UNITED STATES PATENT AND TRADEMARK OFFICE

APPLICATION NO.	FILING DATE	FIRST NAMED INVENTOR	ATTORNEY DOCKET NO.	CONFIRMATION NO.
09/970,015	10/03/2001	Paul Vegliante	2112-342.1 US	2684

Office Action Summary

DETAILED ACTION

Diagram 1. Figure 3 in Lucas.

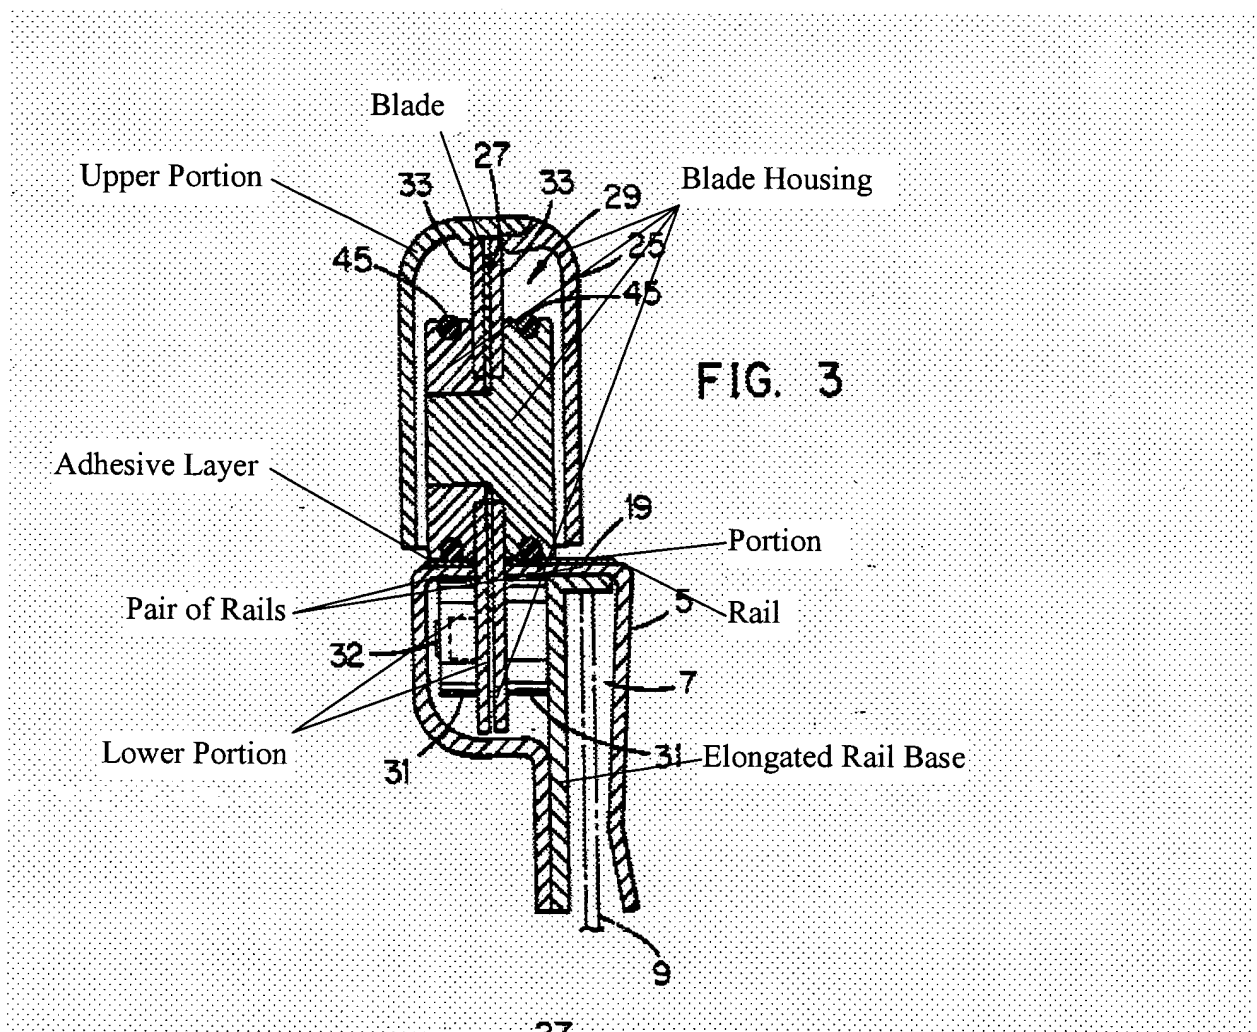
3. Claims 1, 5, 6, 7, 11-17, 20-23, 40 and 44 are rejected under 35 U.S.C. 103(a) as being unpatentable over Lucas, Jr. et al (5,440,961), hereafter Lucas, in view of Wankow (3,549,066). Lucas discloses everything as noted in Diagram 1; channel 13; bottom edge of upper portion of blade housing protrudes on either side of blade in figure 2; end surface of upper portion is rounded and inclined upward as shown in figure 2; tracking device 34; tubular base 31; channel has tubular shape as shown in figure 3; left section 39; right section 35; rivet 37; aperture 51; blade angled from bottom edge at 30 degree angle as shown in figure 2; depression 7; rear edge 5; cover of a carton 9.

4. Claims 18 and 19 are rejected under 35 U.S.C. 103(a) as being unpatentable over the combination of Lucas and Wankow as applied to claim 1 above, and further in view of Keene et al (3,277,760), hereafter Keene. Lucas discloses channel 13; pair of rails, upper section and lower section shown in Diagram 1 below. Lucas does not disclose a protrusion and does not disclose a blade housing that snap fits into a protrusion. However, Keene teaches protrusion 18, 29, 40, and discloses blade housing 40 that snap fits into the protrusion. It would have been obvious to provide a blade housing that snap fits into a protrusion in Lucas as taught by Keene in order to prevent the blade housing from sliding out of the elongated rail base.

5. Claims 35-37, 40 and 42-43 are rejected under 35 U.S.C. 103(a) as being unpatentable over Lucas, Jr. et al (5,440,961), hereafter Lucas, in view of Kaiser et al (5,292,046), hereafter Kaiser. Lucas discloses everything as noted in Diagram 1; channel 13; bottom edge of upper portion of blade housing protrudes on either side of blade in figure 3.
